Access Compliance Report

Public Rights-of-Way

(Curb Ramps)

Intersection ID: 7826	Main Street: BROOKSHIRE_BV	Cross Street: DAKOTA_ST	Location: NW
ADA ID: 8F7D98FAD6EC	Ramp Type: Para	Initial Pass/Fail: Fail	Overall Compliance: No
			Severity Score: 13.75

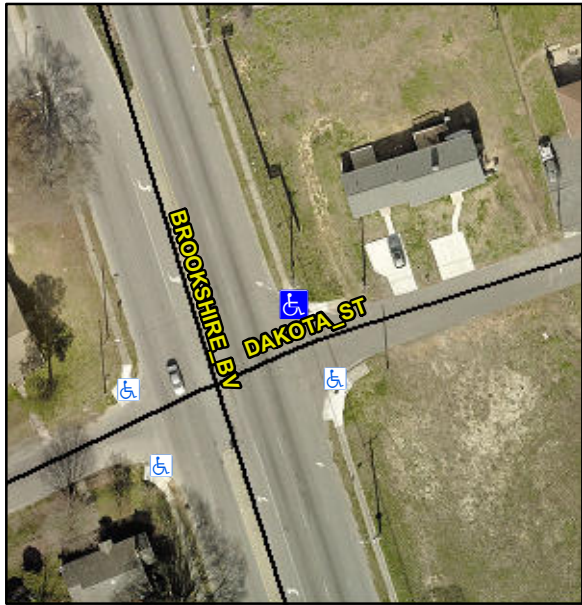
Codes/Mitigation Info/Possible Solution			Field Measurements/Component Compliance					
	Possible Solutions:		Compliance	Description	Data	Compliance	Description	Data
	Remove & Replace Entire Ramp.		N/A	Ramp Length LT (in)	53.0	N/A	Ramp Length RT (in)	65.0
			Yes	Ramp Width LT (in)	54.0	Yes	Ramp Width RT (in)	54.0
			No	Ramp Slope LT (%)	10.9	Yes	Ramp Slope RT (%)	0.7
			No	Ramp XSlope LT (%)	2.4	Yes	Ramp XSlope RT (%)	1.5
			N/A	Landing Length (in)	N/A	N/A	DWS Provided?	N/A
			N/A	Landing Width (in)	N/A	N/A	DWS Contrast?	N/A
			N/A	Landing Slope (%)	N/A	N/A	DWS Length (in)	N/A
			N/A	Landing X Slope (%)	N/A	N/A	DWS Full Width?	N/A
			N/A	Landing Curb? (Y/N)	N/A	N/A	DWS Offset (in)	N/A
Surveyor Notes:		N/A	Shared Landing?	N/A				
RT RP < 5%		N/A	Gutter Ponding?	N/A	N/A	Gutter Slope (%)	N/A	N/A
PROW/ADA:		N/A	Gutter Lip Ht (in)	N/A	N/A	Gutter X Slope (%)	N/A	N/A
R304.3.2, R304.5.3		N/A	Painted X Walk1?	No	N/A	Painted X Walk2?	N/A	N/A

X Walk 1 Direction	To SE		X Walk 2 Direction	N/A	N/A
		N/A	X Walk 1 Width (in)	N/A	N/A	X Walk 2 Width (in)	N/A	N/A
			X Walk 1 Slope (%)	4.9		X Walk 2 Slope (%)	N/A	N/A
			X Walk 1 X Slope (%)	6.3		X Walk 2 X Slope (%)	N/A	N/A
		N/A	Ramp inside XWalk1?	N/A	N/A	Ramp inside XWalk2?	N/A	N/A
			Road Slope (%)	N/A	N/A	Clear Space?	N/A	N/A
			Road X Slope (%)	N/A	N/A	Clear Space to XWalk (in)	N/A	N/A
		N/A	Any Obstructions?	N/A	N/A	Storm Grate/Utility Hazard?	N/A	N/A
			Obstruction Type			Storm Grate/Utility Type		
Total Cost:		\$ 1600.00			N/A			N/A
						Yes	Surface Condition? (G/P)	Good
						N/A	Curb Slope (%)	25.1
